MAXINE HALL HEALTH CENTER RENOVATION AND SEISMIC UPGRADE

CIVIC DESIGN REVIEW - PHASE 3 : JUNE 25, 2018

MAXINE HALL HEALTH CENTER
RENOVATION AND SEISMIC UPGRADE
REVISIONS AFTER CDR 2 (11/27/2017) APPROVAL

SOUTH ELEVATION - GRAPHIC WALL (NEWLY PROPOSED)

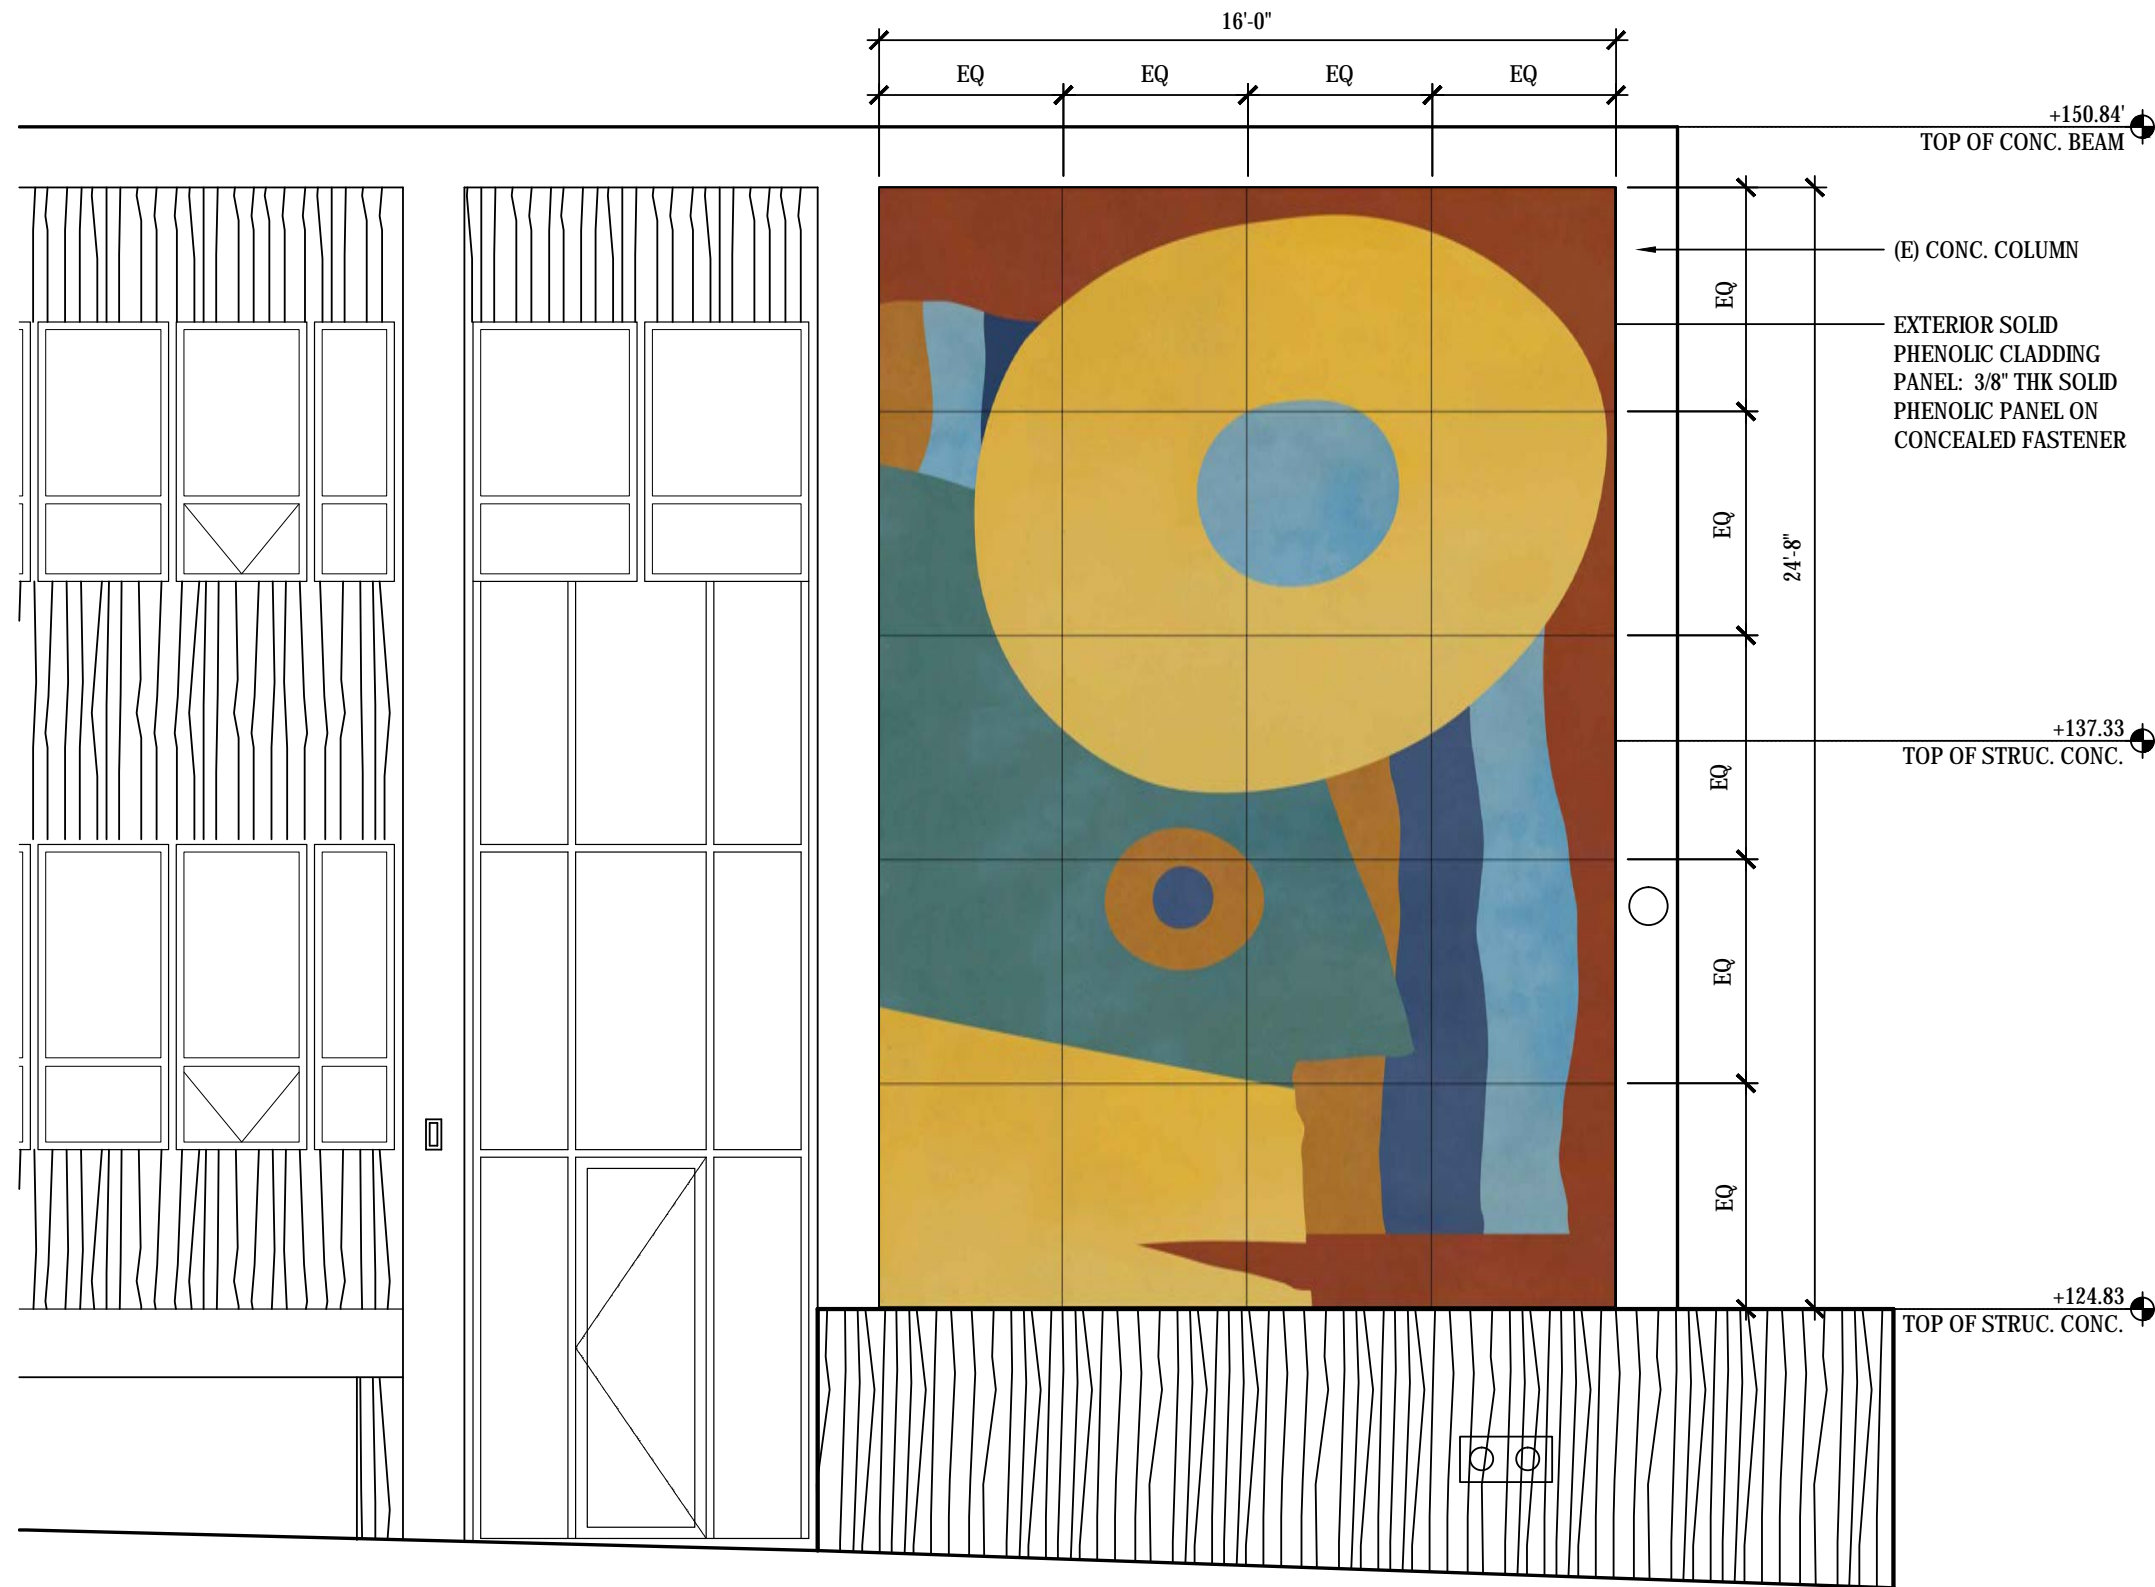
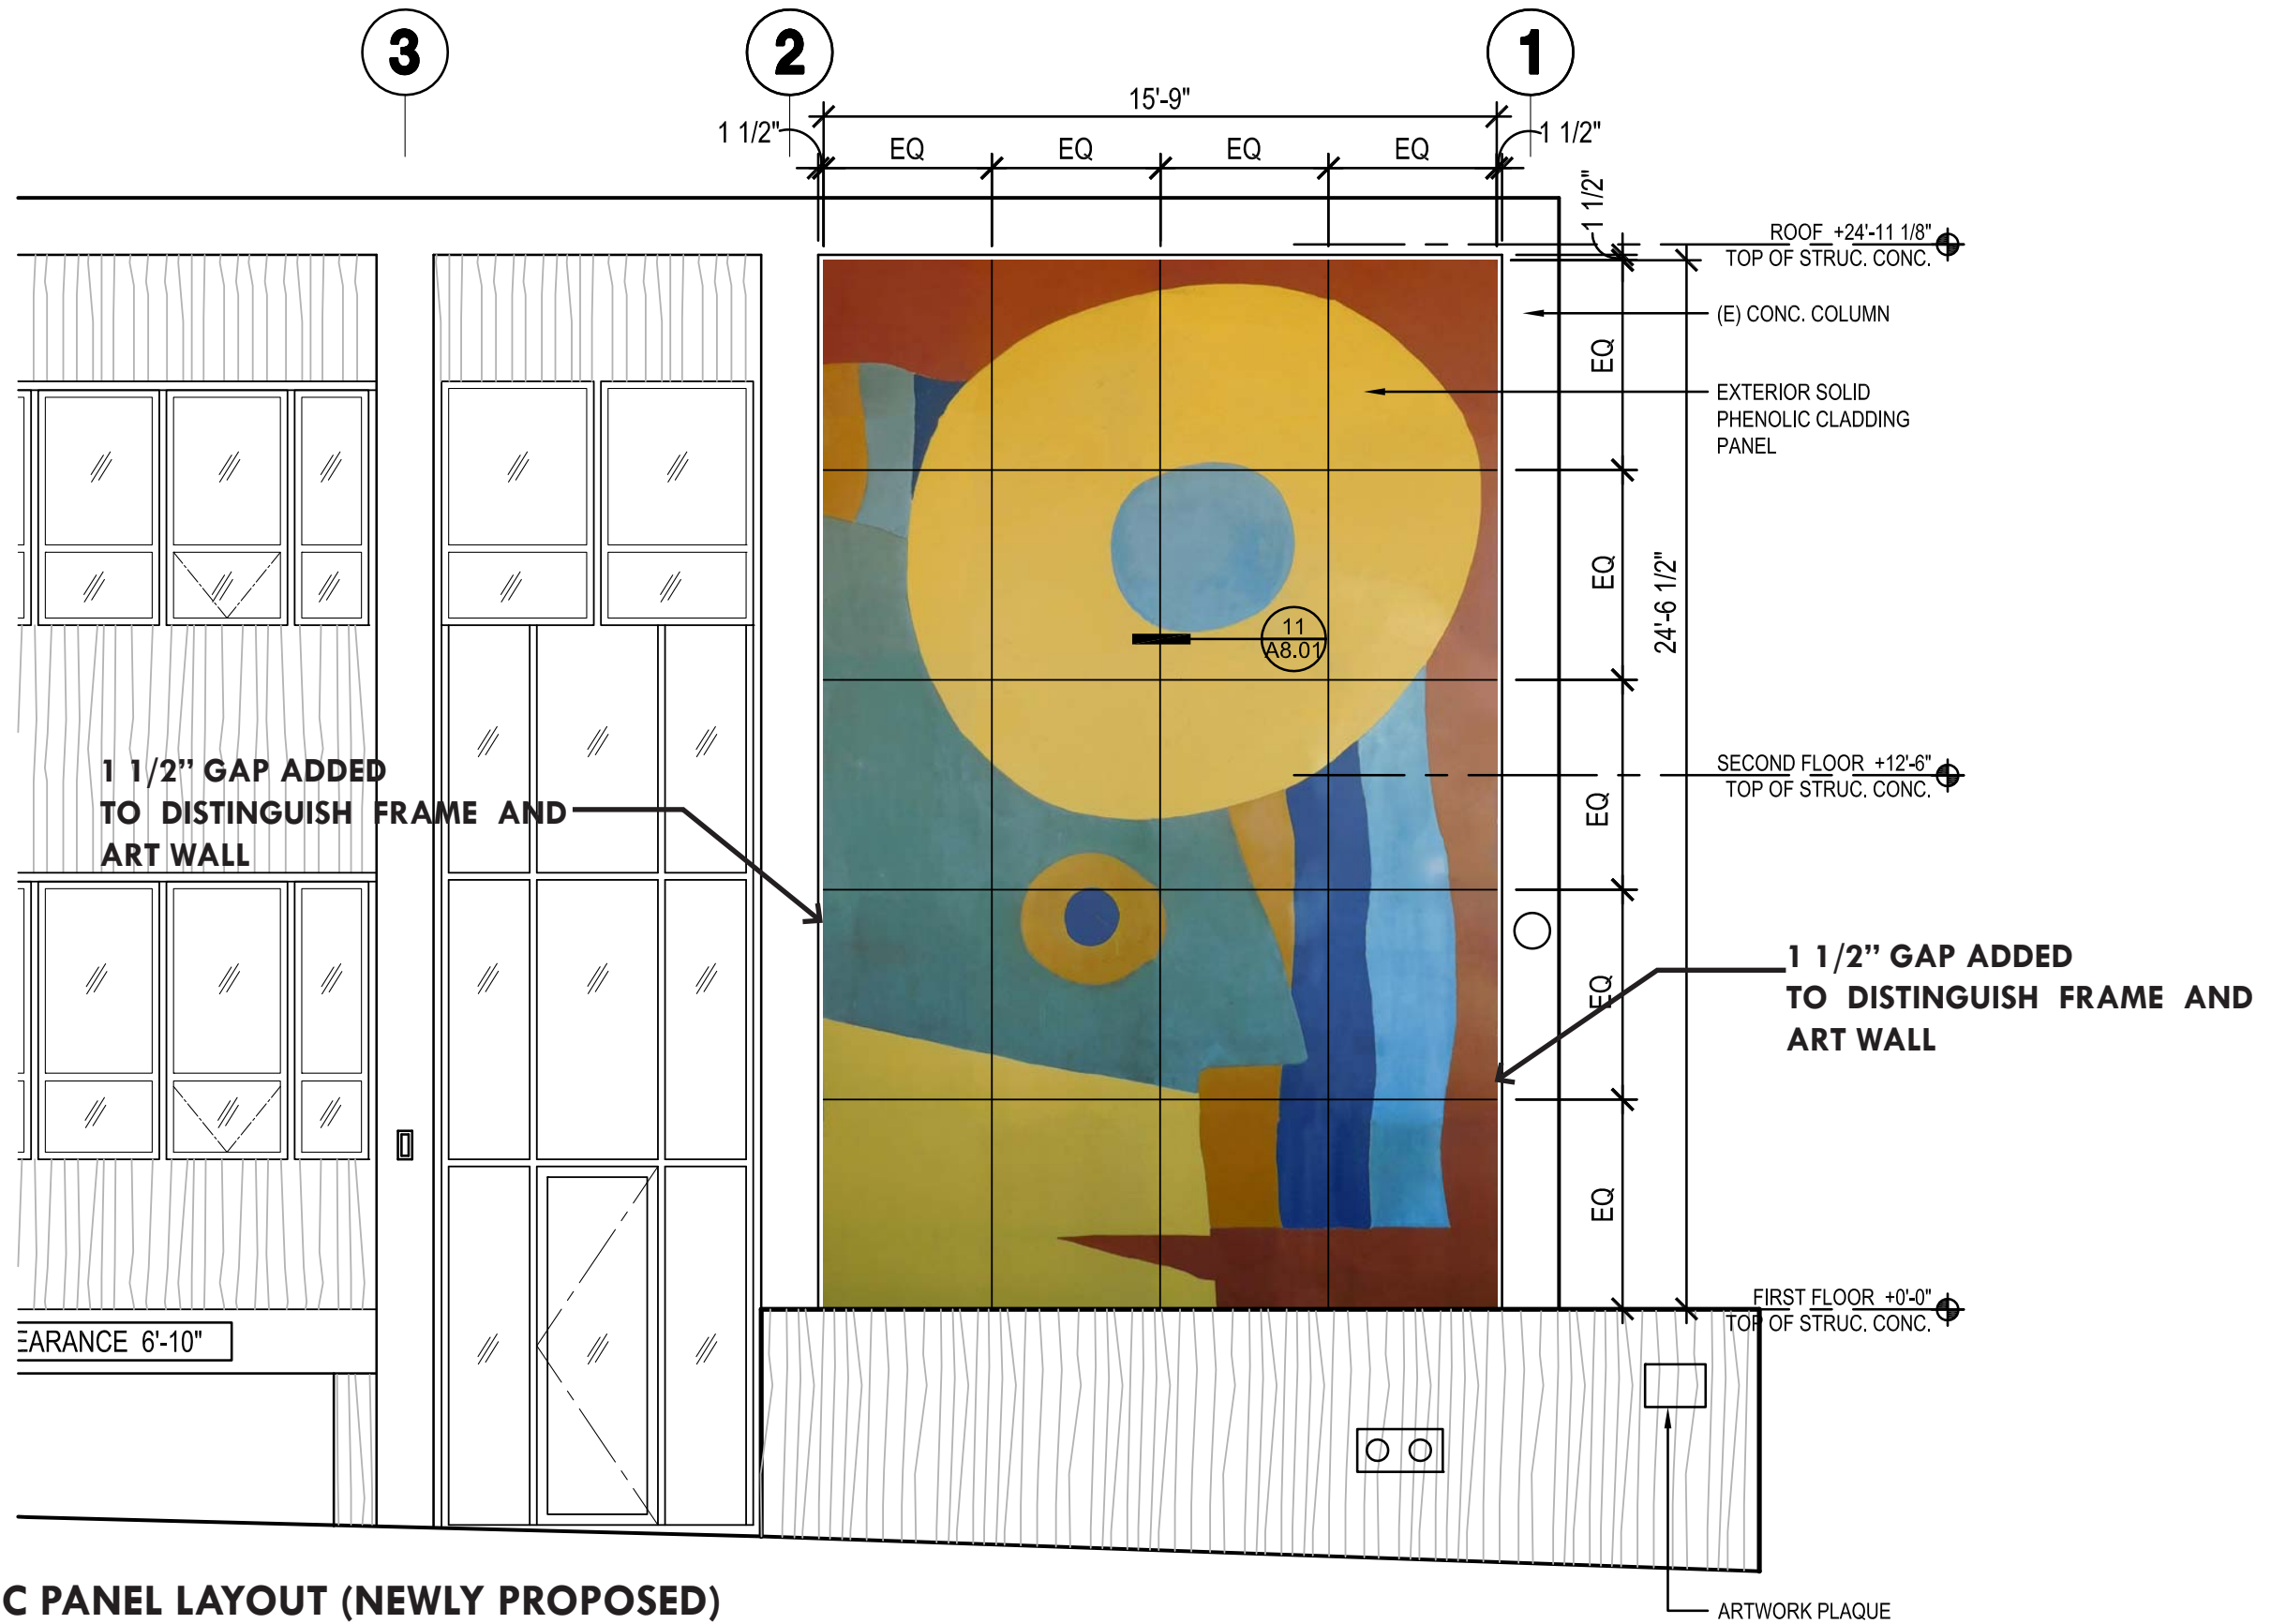
1. South Elevation Graphic Wall :

We are proposing a minor revision to the Graphic Wall; The concrete shear wall is now moved to the interior of the building, allowing the exterior plane of the graphic wall to be set back from the surrounding concrete frame in keeping with the existing historic facade. (Revision per Historic Preservation planning recommendation)
